Yucca Mountain Site Characterization Project

***Technical Guidance Document for
License Application Preparation
YMP/97-03***

Revision 1

September 1999

Figure 3.6-1 Saturated Zone Profile (0.5 mm sand, episodic flood)

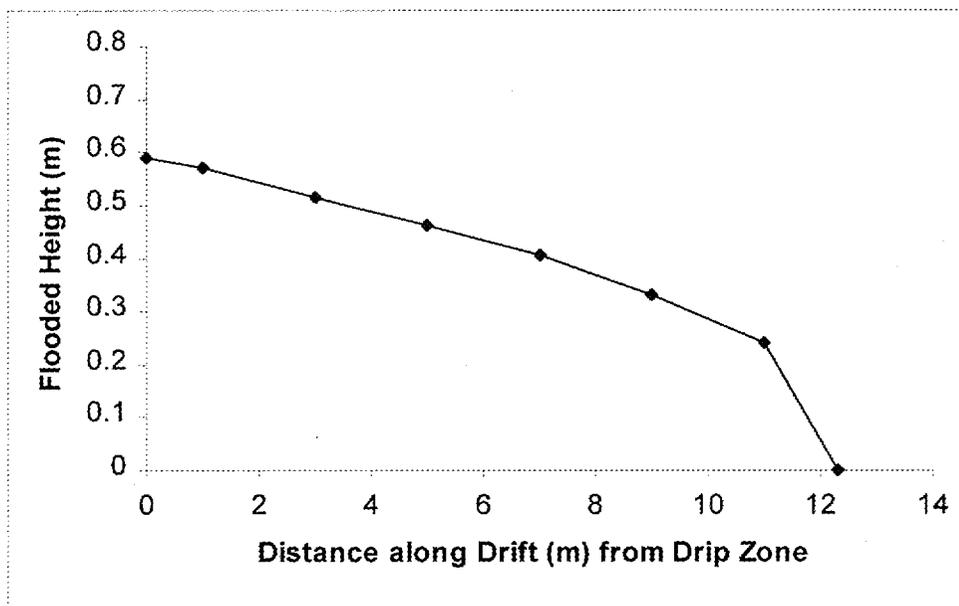
- 3-7 *Explain why, in item 3, configuration NF-1b includes only a reducing reaction with tuff as a mechanism for precipitation of fissile solutes in the near-field below the waste package.*
